GLOBAL SAFETY FIELD INVESTIGATIONS
DCS6654
URGENT - DISTRIBUTE IMMEDIATELY

Subject: N232409000 - Service Update
Engine Wiring Harness Chafe

Models: 2023 Chevrolet Colorado
2023 GMC Canyon

N232409000 Engine Wiring Harness Chafe

6408262

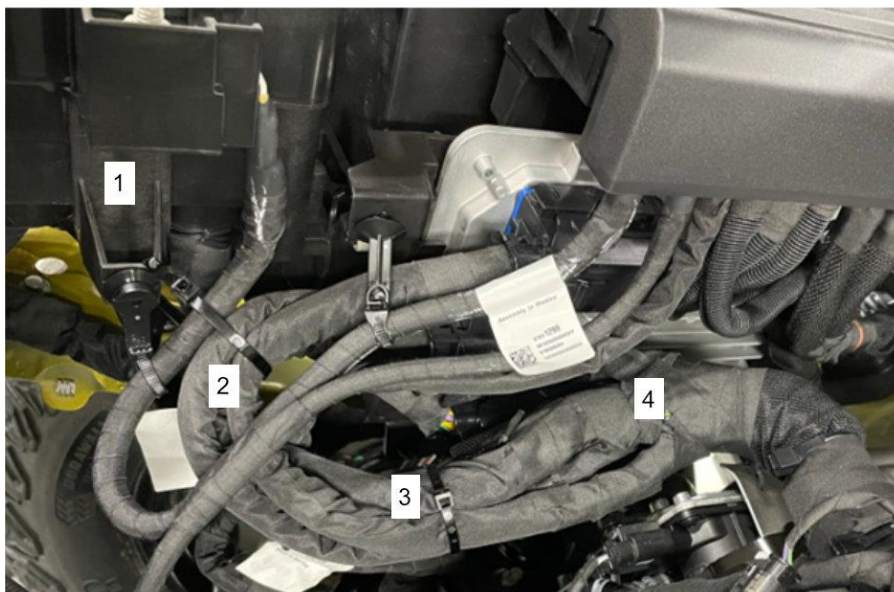
Condition	Certain 2023 model year Chevrolet Colorado and GMC Canyon vehicles may have a condition where there is insufficient clearance between the wiring harness and the turbo actuator.
Correction	Dealers are to install cable ties to the engine wiring harness.

2. Find the mounting extension on the fuse block bracket (1).

3. Use the first cable tie (2) to loop around the three ECM wiring leads and the mounting extension on the fuse block bracket.
 - a. Tighten and trim excess cable tie.
4. Follow the three ECM wiring leads to their intersection with the main engine harness (4)
5. Use the second cable tie (3) to loop around the 3 ECM wiring leads and the main engine harness, at approximately 100mm from the point where the leads meet the main engine harness.
 - a. Tighten and trim excess cable tie.
6. Install air cleaner outlet duct. Refer to *Air Cleaner Outlet Duct Replacement* in SI.
